Subject: Mine Ventilation Plan, Section 75.370, 30 CFR 75, Upper
Big Branch Mine-South, I.D. No. 46-08436, Performance
Coal Company, Montcoal, Raleigh County, West Virginia

RE: Upper Big Branch Mine
State ID - U-3042-92
M.S.H.A. ID 46-08436
Revised Ventilation Supplement for Coal Transfer Shaft

**Upper Big Branch Mine
MSHA ID 46-08436
STATE ID U-3042-92
Coal Transfer Shaft
Ventilation Supplement
Revised Page (10/4/2005)
Pilot Hole**

PILOT HOLE

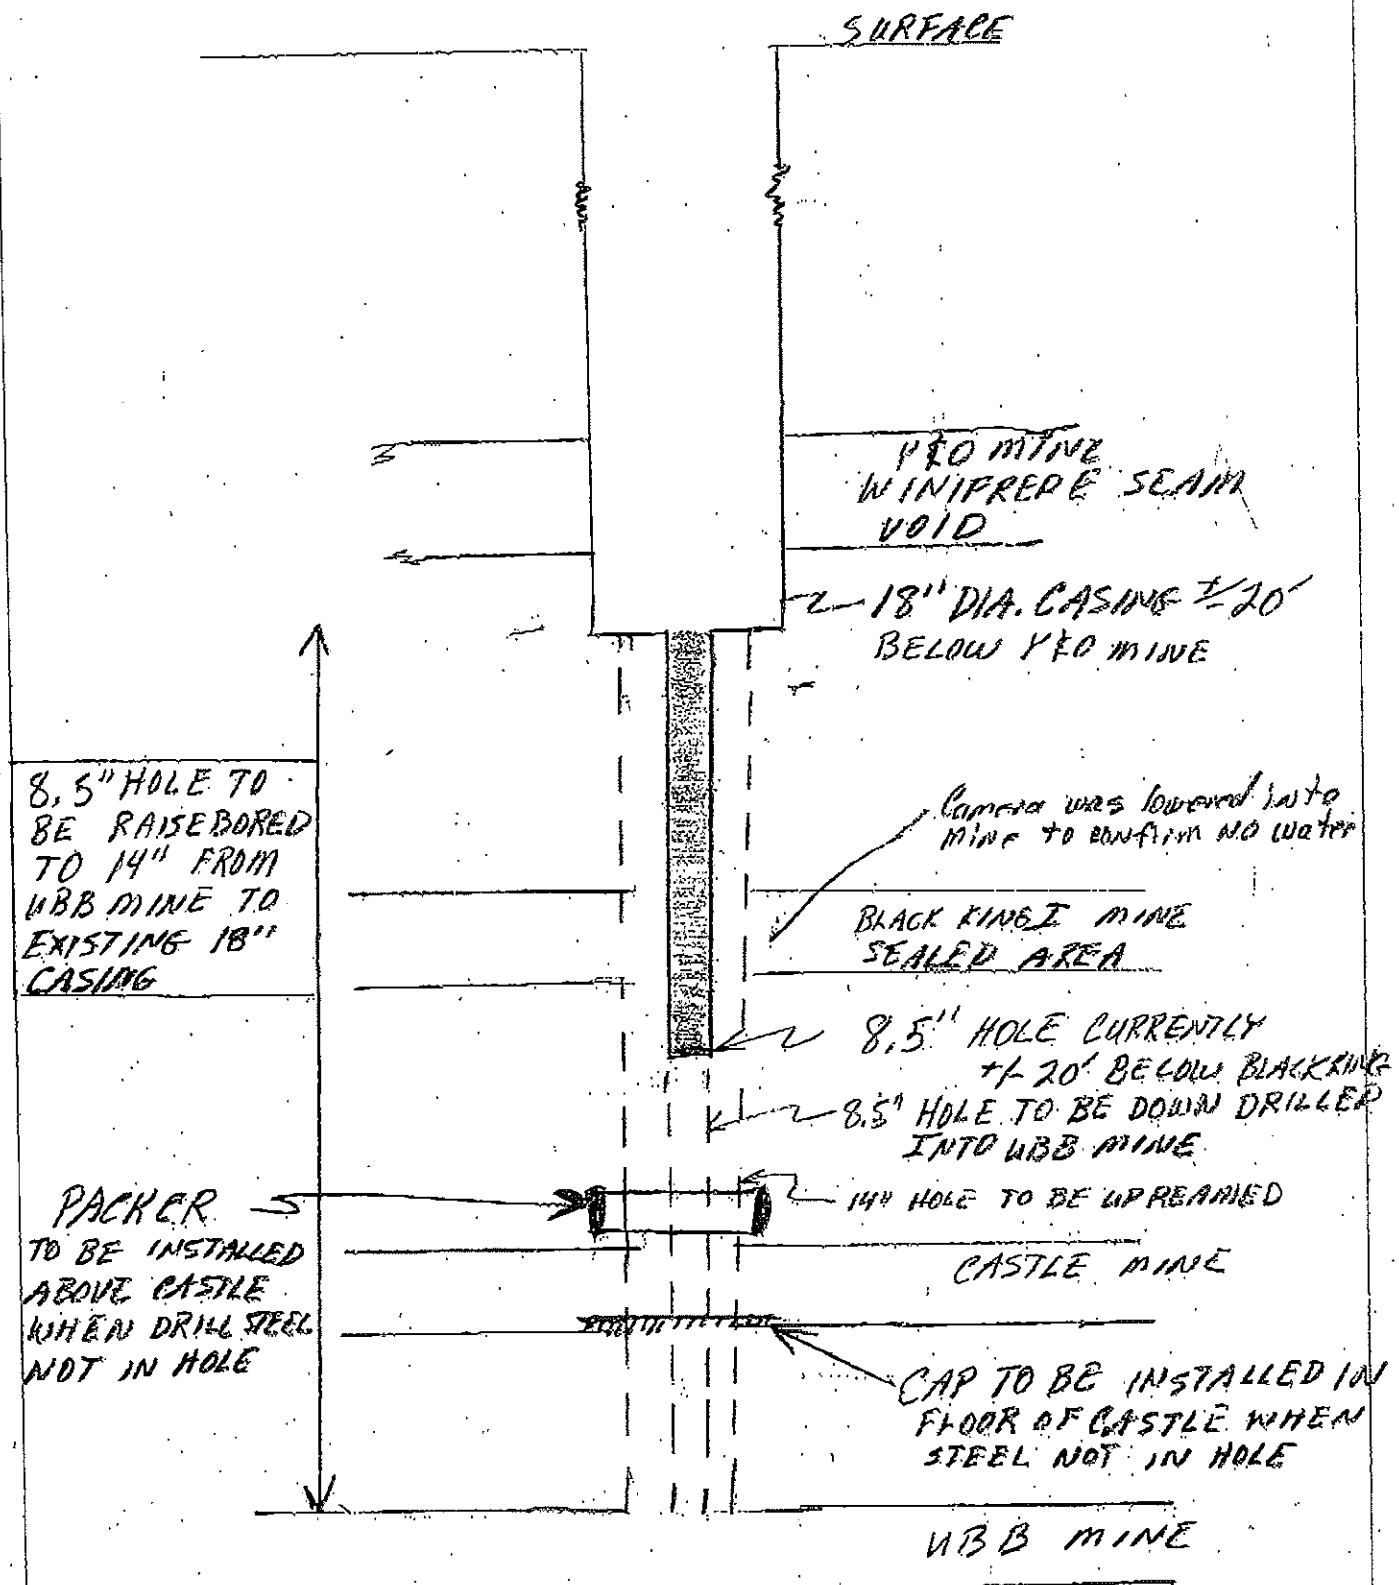
Enclosed please find a revised page 1 of a ventilation supplement. Our current approved plan states that the pilot hole will be cased off from all voids as it is drilled. We have cased the 1st 500 feet of the hole down through the abandoned Y&O mine in the Winifrede seam. When we drilled below the casing the pilot hole deviated from the required course. We then used a directional drilling company to steer an 8.5" hole back on course down into the floor of a sealed portion of our Black King I mine. When we attempted to ream this hole to 18" (which would allow casing to be run) the hole deviated off course in the same direction as the first. The drilling contractor believes that further attempts would result in similar deviations.

The attached plan shows directional drilling of an 8.5" hole on into the Upper Big Branch Mine. There the bit will be changed to 14". This will allow the pilot hole to be raise bored to the usable diameter. The attached plan shows that the Lower Cedar Grove seam was verified by camera for water and how air seperation between the seams will be accomplished.

1. The first 500 feet of the pilot hole will be steel cased.
2. An 8.5" directionally steered hole was drilled into the floor of the Black King I mine. A camera was lowered into the hole. The video verified that no impounded water exists at the location of the hole.

3. The pilot hole will drill into the Castle mine where mining has already occurred. Access to this area will be dangered off during drilling. Once drilling breaks through into the Castle mine preshift examinations will begin and continue through out the process.

4. The pilot hole will drill into the Eagle seam where mining has already occurred. Access to this area will be dangered off during drilling. Once drilling breaks through into the Upper Big Branch mine preshift examinations will begin and continue through out the process.

5. The 8.5" bit on the drill steel will be changed to a 14" reaming bit. This bit will be used to raisebore the 14" pilot hole up to the 18" steel casing (500 foot from the surface).

6. During all times either drill steel or a packer will exist in the hole between the Castle mine and the sealed area of the Black King I mine above. When it is necessary to install or remove a packer the area will be constantly monitored for direction and quality (methane and oxygen).

7. After reaming the pilot hole to 14" between the UBB mine and the Castle mine a cap with a valve for sampling will be installed over the pilot hole in the floor of the Castle mine. The 14" hole will proceed to be enlarged above the Castle mine. The hole can be enlarged until it is 5 feet below the Black King mine floor. A packer will then be installed in the roof of the Castle mine. Then the hole can be enlarged the remainder of the distance.

8. The raise bore drill rig will be installed on the surface. Before the drill string for the raise bore is lowered through the Castle mine roof the packer will be removed. Checks will be made for direction and quality before the packer is removed. Before the drill string can be lowered below the Castle mine floor the cap separating the Castle and UBB mines will be removed. The air will be sampled before the cap is removed. Then the drill string will be extended down into the Upper Big Branch Mine. Air ventilating the area will be directed into the return.

9. The raise bore will then excavate the shaft between the 2 seams. See page 2 for raise bore details.
10. After the raise bore drill string has been removed above the Castle mine, but still extends down below the Lower Cedar Grove seam, a packer will be installed. The hole will then be grouted off above the Castle Mine.

The revision is hereby approved and will be made a part of the approved plan for this mine.
